SUBJECT: Describes leak rate calculation in response to NRC request
 for addl info re eddy current insp results & summary of leak
 rate calculations per 840323 request for approval to install
 no more than 10 addl tubesheet sleeves.

Subject: Steam Generator Tubesheet Sleeves
R. E. Ginna Nuclear Power Plant
Docket No. 50-244

FIGURE 1

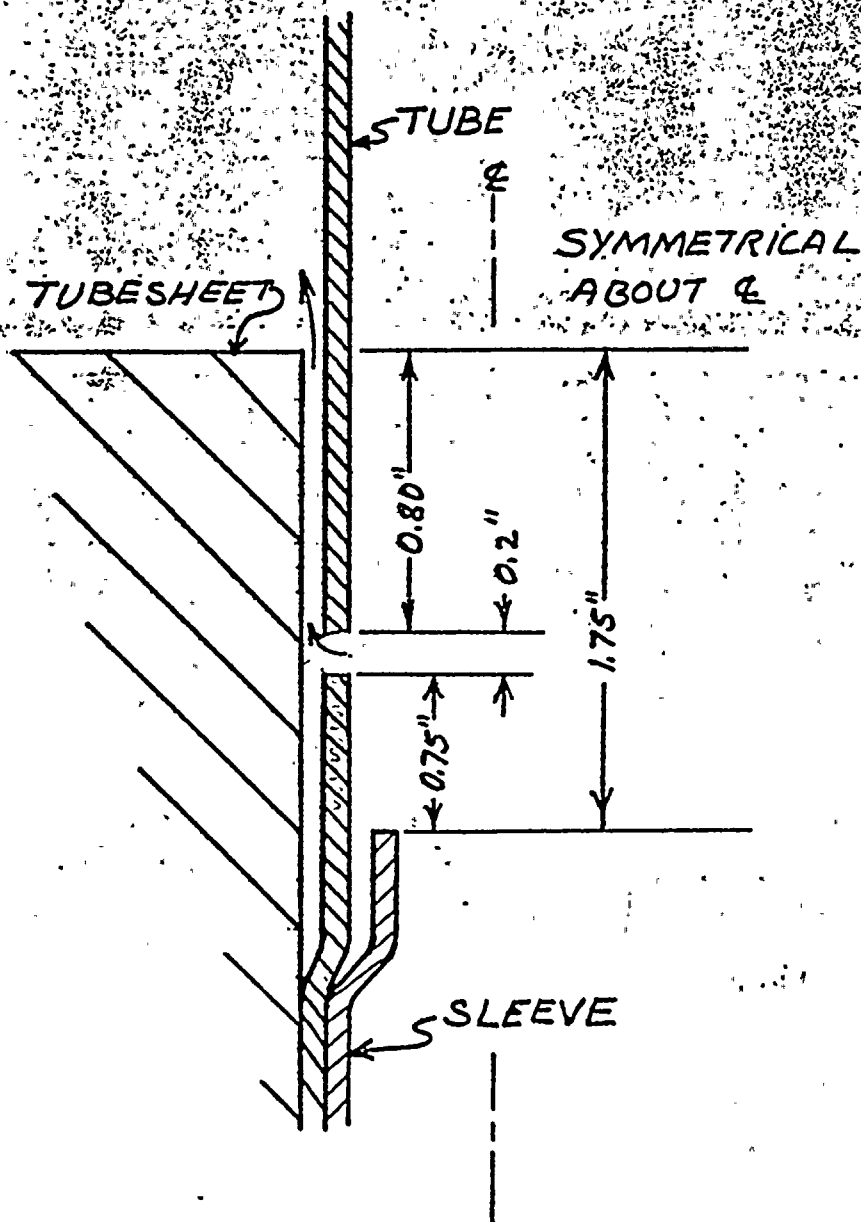
The area of the tube with minimum inspectability extends from the top of the sleeve to approximately 0.75 inches above the top of the sleeve. At this point, as detailed in our letter of March 23, 1984, a defect can be detected but not sized. Because of this, a leak is postulated at this point as shown on Figure 1. Assuming 0.2 inches of pullout due to pressure loading on the tube, the leakage path is 0.8 inches. As shown on Figure 2 the resultant maximum leakage flow rate can then be determined as 23 GPM. This leakage value is conservative considering the assumption of non-equilibrium conditions. The actual leakage value would be expected to be lower.

FIGURE 2

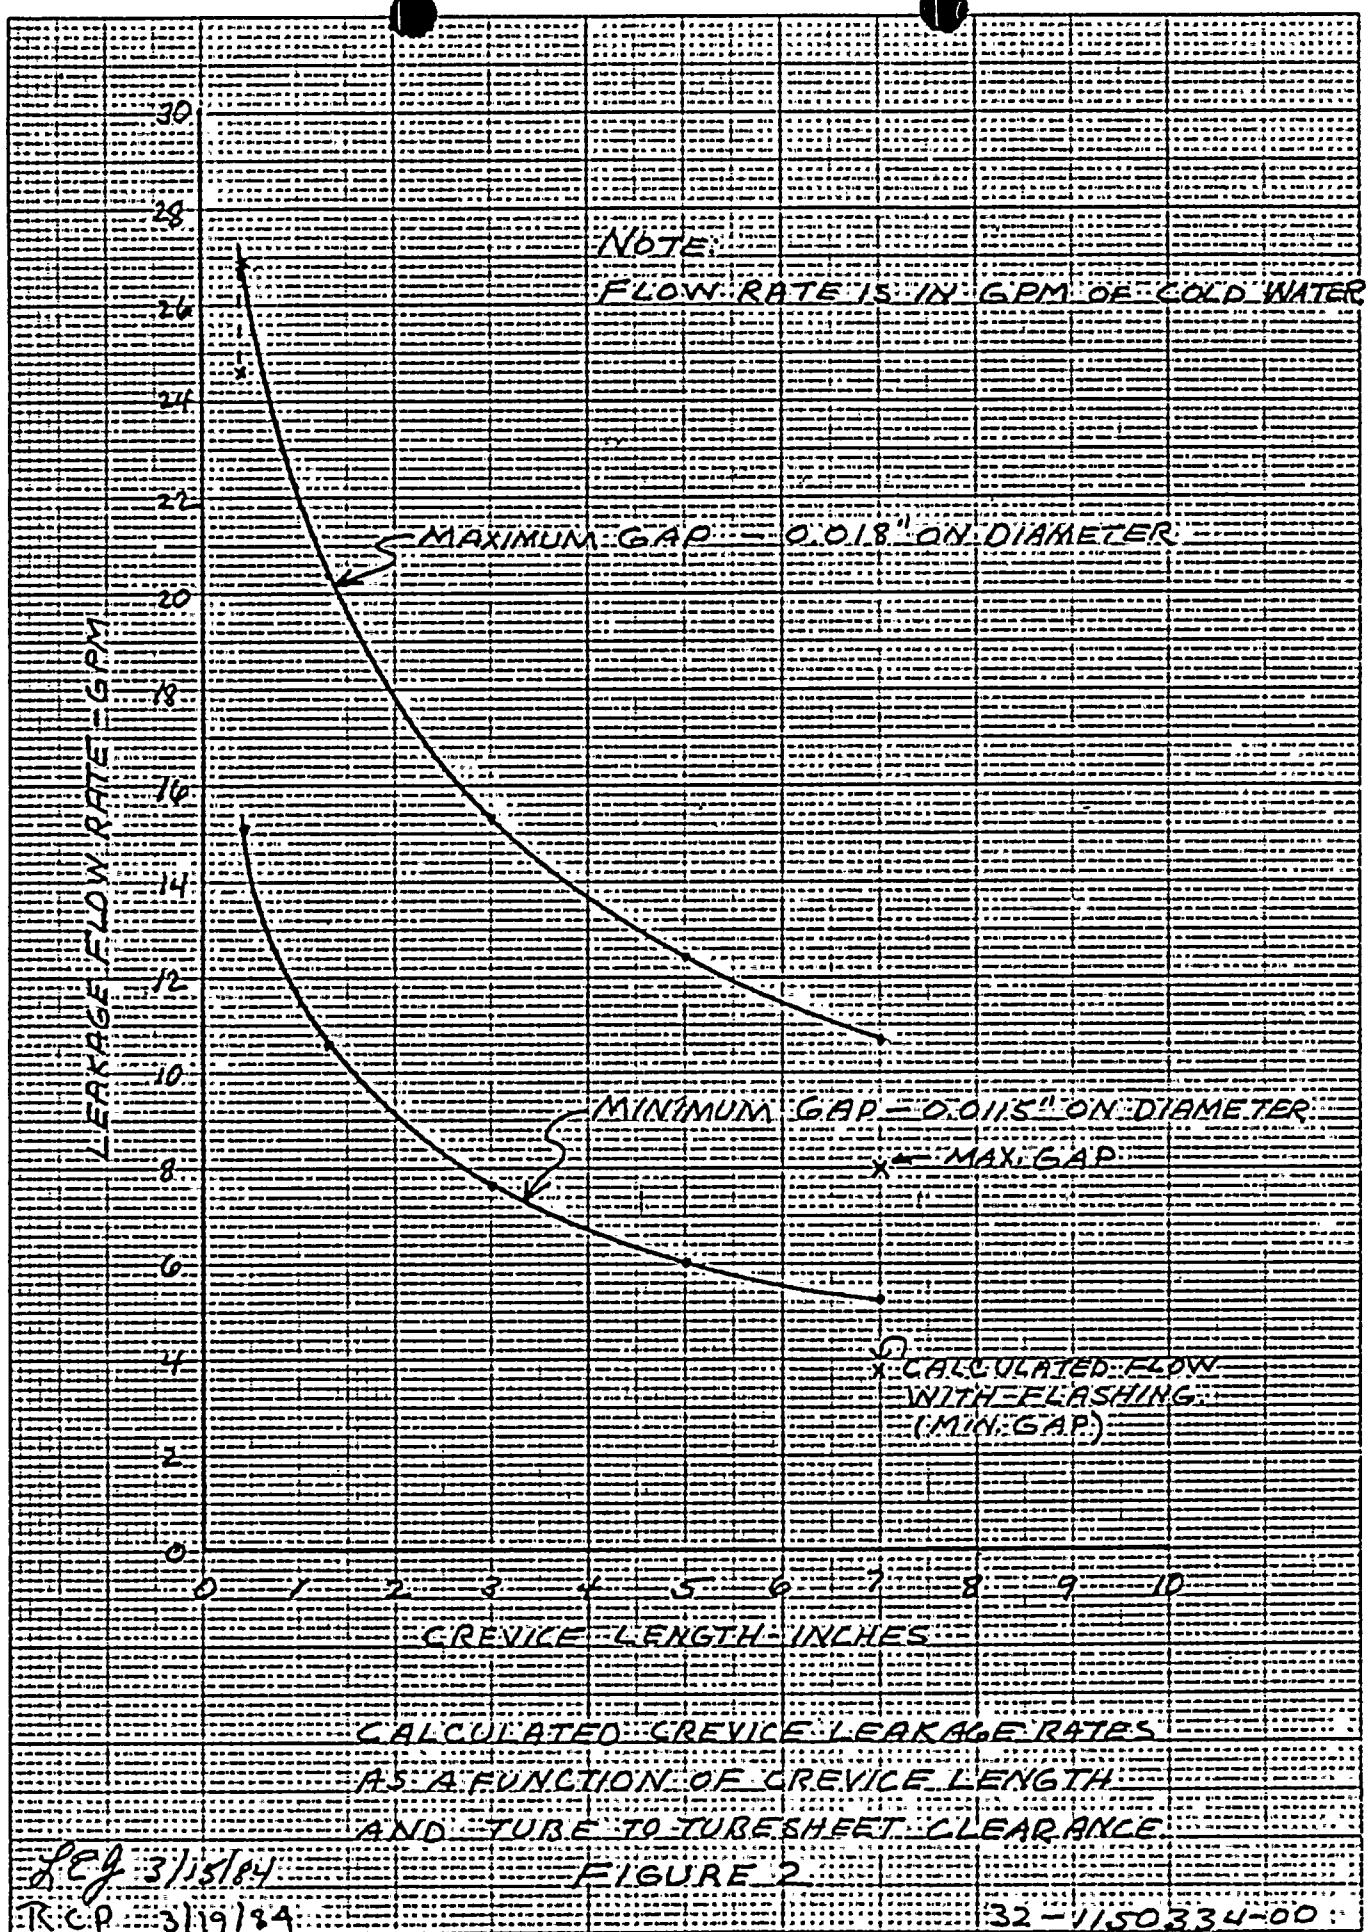
Based on these assumptions, the expected leakage flow was calculated for break elevations from 0.4 inches to 7.0 inches below the secondary side of the tubesheet for both maximum and minimum annular gaps between the tube and tubesheet. These curves are given on Figure 2. It should be noted that the leakage rate would drop dramatically if the break elevation exceeds 1.75 inches from the secondary face of the tubesheet. This is because the flow path then involves two annuli; sleeve/tube and tube/tubesheet.
